Product consolidation DRM relays

Type of notification: ☒ PCN ☐ PDN ☒ Short-term action (<6 months)

Before: (view from the bottom on the relay pins)

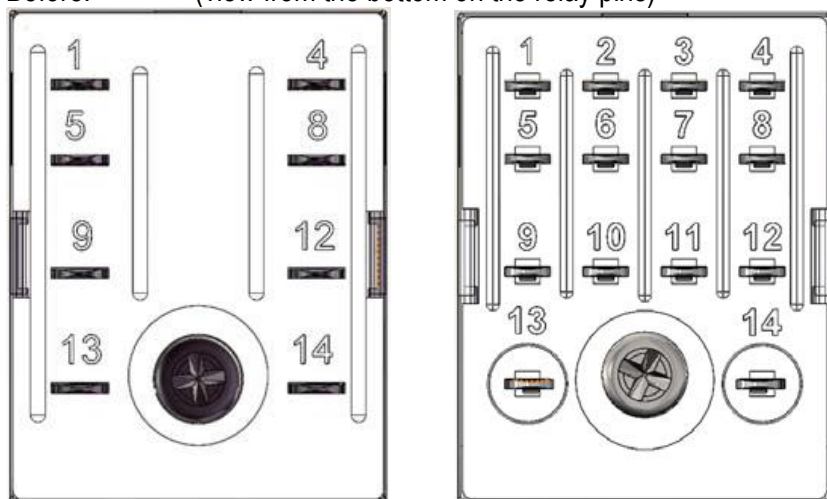
- Visual change:
 - The fonts of the bottom pin numbers are different between before and new.
 - There is no screw in the bottom of new version.
